COMMUNICATION AND NETWORKING RISER ECR FORM

ECR# (assigned internally): #005

Title of the Change: CDC_DN_ENAB# pull-up resistor change

Specification Title and Version: CNR Specification, Version 1.0

Figure 11 – CDC_DN_ENAB# support circuitry for a single codec motherboard

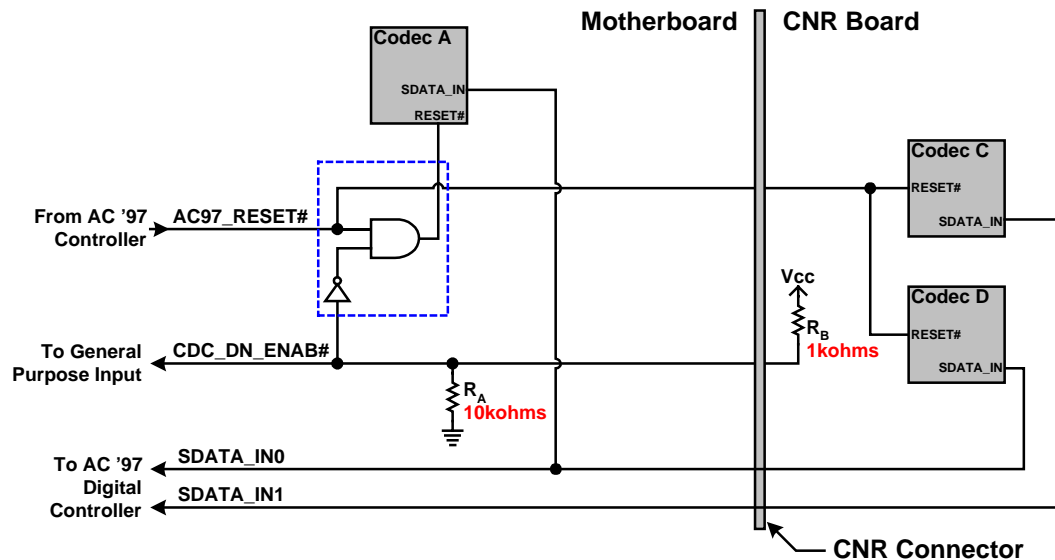
As shown in Figure 11, when a single codec is located on the motherboard, the resistor R_A and the circuitry (AND and NOT gates) shown inside the dashed box must be implemented, on the motherboard. This circuitry is required in order to disable the motherboard codec when a CNR is installed which contains two AC '97 codecs (or a single AC '97 codec which must be the primary codec on the AC-Link). In addition, the AC '97 codec on both the motherboard and the CNR must be compliant with all of the latest Engineering Change Notices (ECN) and specification updates for the AC '97 specification.

By installing resistor R_B (1kohm) on the CNR, the codec on the motherboard becomes disabled (held in reset) and the codec(s) on the CNR take control of the AC-Link. One possible example of using this architecture is a system integrator installing an audio plus modem CNR in a system already containing an audio codec on the motherboard. The audio codec on the motherboard would then be disabled, allowing all of the codecs on the CNR to be used.

Figure 12 – CDC_DN_ENAB# support circuitry for multi-channel audio upgrade

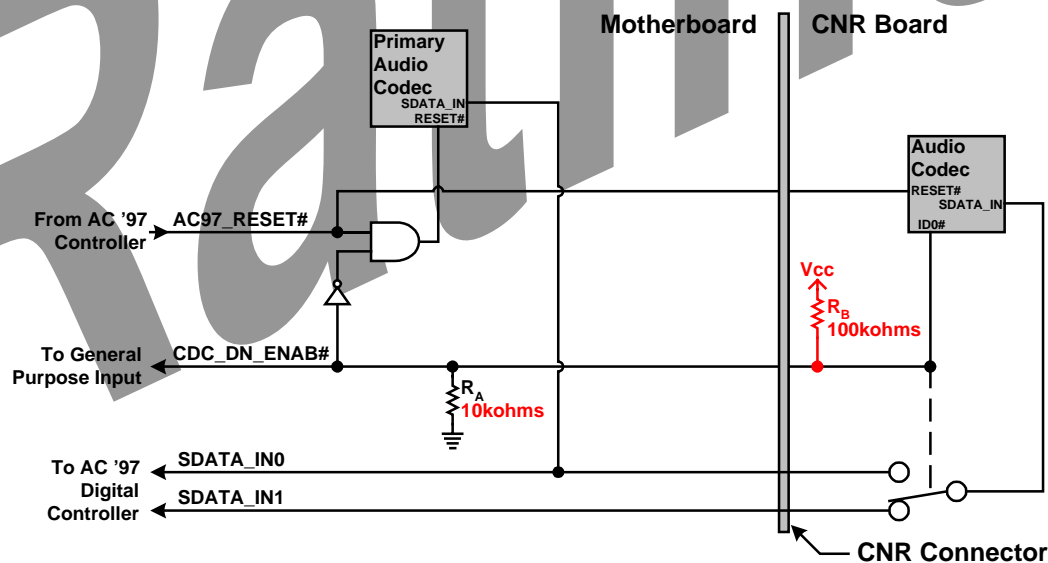
The architecture shown in Figure 12 has some unique features. These include the possibility of the CNR being used as an upgrade to the existing audio features of the motherboard (by simply not installing changing the value of resistor R_B on the CNR to 100kohms). An example of one such upgrade is increasing from two-channel to four or six-channel audio (see Section 6.3.2 for more information on multi-channel audio upgrading).

Note: All CNR designs must include resistor R_B . The value of R_B must be either 1kohm or 100kohm, depending on the intended functionality of the CNR.
